fcREQUEST FOR INFORMATION

Project Name: York Region Admin., Package D Renovation

CONSULTANTS RFI NO: TC24-114-17-X

York Region Building 4th floor issues

M-215

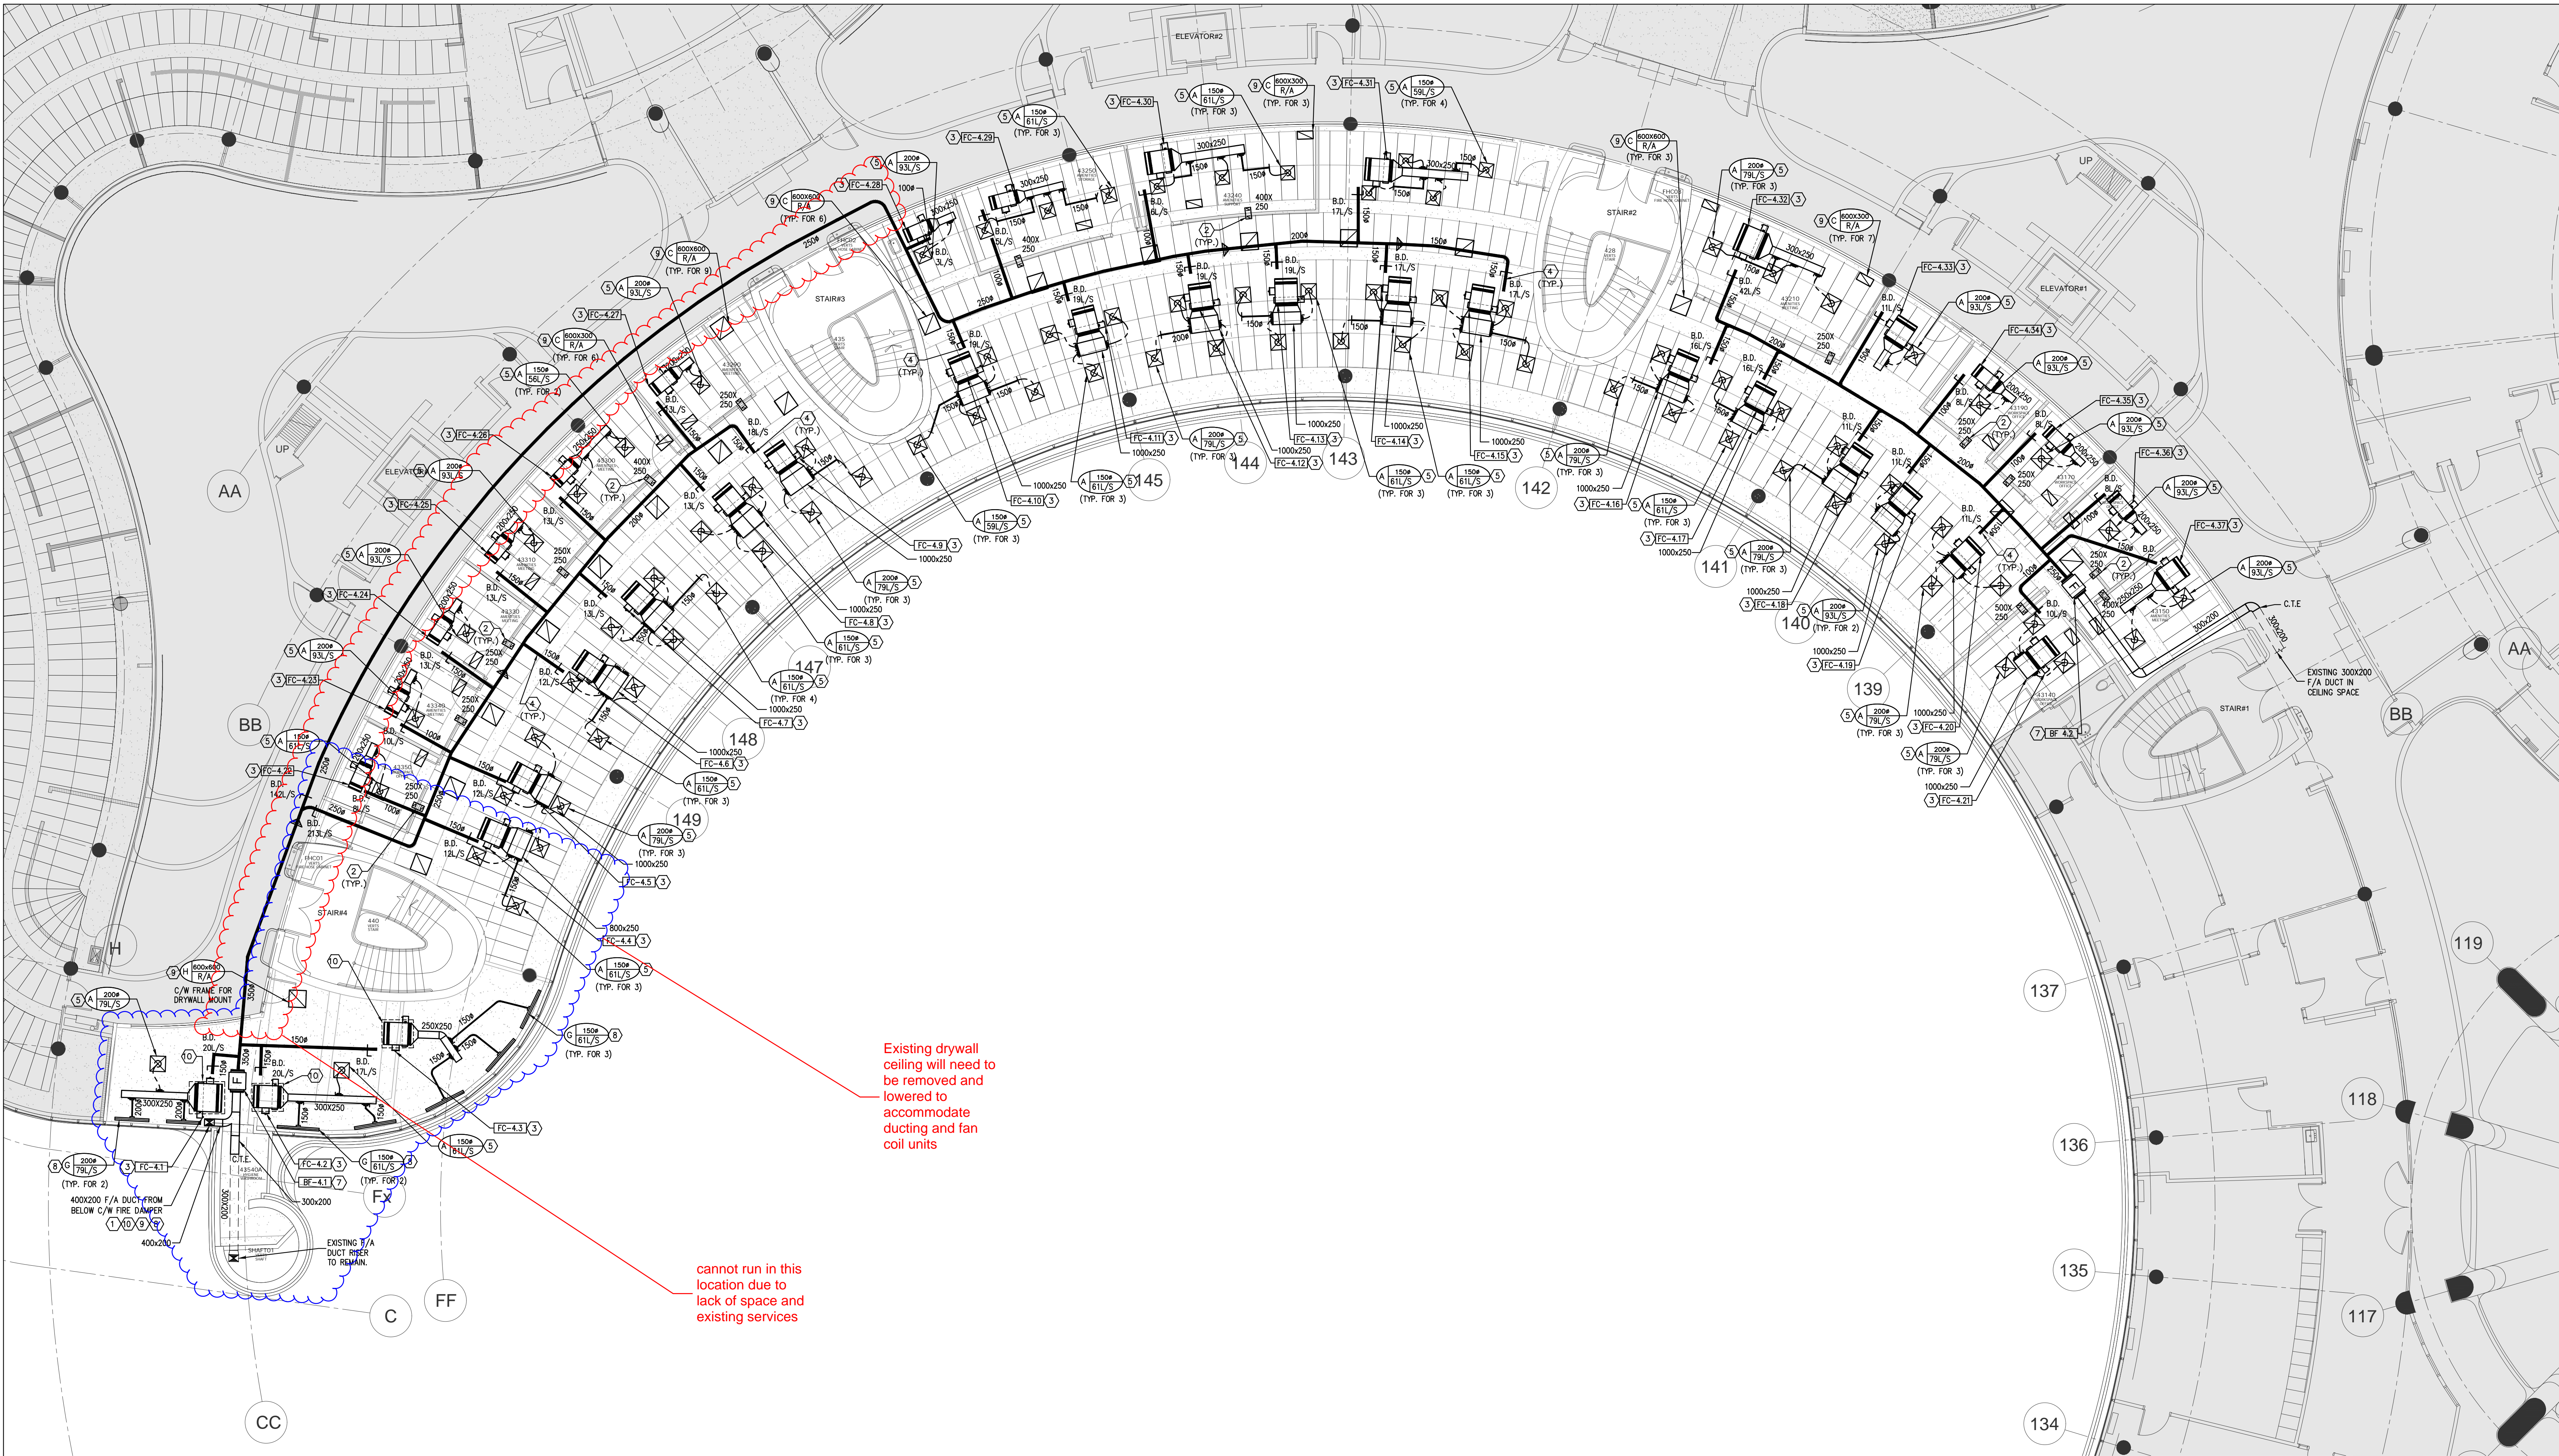
Please refer attached, we can not run the main duct down the hallway as shown due to no space and existing services. We can run it inside the space, but existing drywall ceiling will need to be removed and lowered. Kindly advise the way forward.

GPY Response: Please refer to demolition drawings (M-207), existing services (F/A Duct, CHS/CHR, HWS/HWR, Exist. FCU's) located in ceiling space are shown to be removed in these areas. Existing services are cut back and cap near risers for new connection.
